ZONING AMENDMENT

& SUBDIVISION STAFF REPORT Date: November 6, 2008

APPLICANT NAME Joseph Payne

SUBDIVISION NAME Grant Street East Subdivision

SITE PLAN

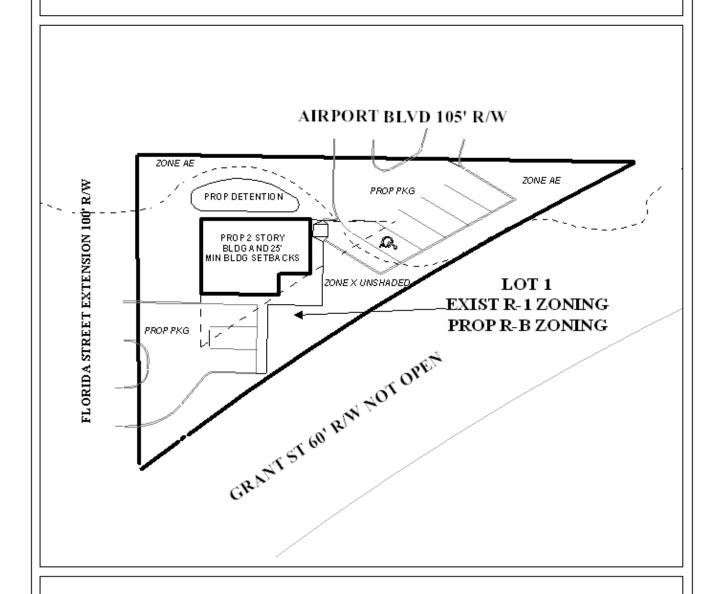
Driveway number, size, location, and design to be approved by Traffic Engineering and conform to AASHTO standards. Final approval for all driveways, proposed and existing will be given upon submittal of final plans. No details were given showing the driveway radii or connection to the right-of-way of either Florida Street Extension or Airport Boulevard. The angled parking does not provide adequate space for vehicles to maneuver. Changes should be made to accommodate the minimum standards required parking and driveway design.

The applicant is proposing two one-way curb cuts onto Airport Boulevard and two one-way curb cuts onto Airport Boulevard. Due to the size and configuration of the property boundaries, access management is a concern. Airport Boulevard and Florida Street are both major streets with high traffic counts. The high traffic counts alone would be enough to warrant limiting, if not denying, access to Airport Boulevard and the Florida Street Extension. Additionally, the site has unique topographical concerns. Mainly, there is a 4 to 6 foot elevation change between Airport Boulevard and the property line, which would create line-of-site and safety concerns. For this reason, it is recommended that the site be denied access to both Airport Boulevard and the Florida Street Extension. The frontage along the unopened portion of Grant Street is adequate to allow two curb cuts.

There are several options for access. The applicant could consider accessing the site from Grant Street, or the applicant could consider petitioning for vacation of the unopened Grant Street right-of-way, or the applicant could consider working out a solution with traffic engineering for a curb cut onto the Florida Street Extension and applying for a variance from the front yard setback requirements along the unopened Grant Street right-of-way. In any event, these access issues need to be worked out in consultation with applicable City departments before the subdivision or the rezoning is approved.

The 25-foot minimum building setback is depicted on all street rights-of-way, and this should be retained in the final plat. Additionally, the size of the lot in square feet, or a note containing the same information, should be placed on the plat.

Urban Forestry has commented that there is a 48" Live Oak tree on the site that should be given preservation status. As the said tree was not depicted on the site plan, and given the limited

space already, the site plan may need to be revised to reflect the preservation status of this tree. Therefore, the site plan should be revised to reflect any changes which would result from the preservation of this tree.

- 1) Address comments on site accessibility and parking and revise the site plan accordingly;
- 2) Address comments from Urban Forestry regarding tree preservation to include revision of the site plan to reflect the preservation of the 48" Live Oak tree;
- 3) Show compliance with Section V.B.16 of the Subdivision Regulations regarding curb radii;
- 4) Provision of labeling of the size of the lot or a table with the same information on the plat; and
- 5) Compliance with all engineering comments: Show Minimum FFE on plans and plat. No fill allowed within a special flood hazard area without providing compensation or completing a flood study showing that there is no rise for the proposed fill within the special flood hazard area. Must comply with all storm water and flood control ordinances. Any work performed in the right of way will require a right of way permit.

- 1) Address comments on site accessibility and parking and revise the site plan accordingly;
- 2) Address comments from Urban Forestry regarding tree preservation to include revision of the site plan to reflect the preservation of the 48" Live Oak tree;
- 3) Show compliance with Section V.B.16 of the Subdivision Regulations regarding curb radii;
- 4) Provision of labeling of the size of the lot or a table with the same information on the plat; and
- 5) Compliance with all engineering comments: Show Minimum FFE on plans and plat. No fill allowed within a special flood hazard area without providing compensation or completing a flood study showing that there is no rise for the proposed fill within the special flood hazard area. Must comply with all storm water and flood control ordinances. Any work performed in the right of way will require a right of way permit.
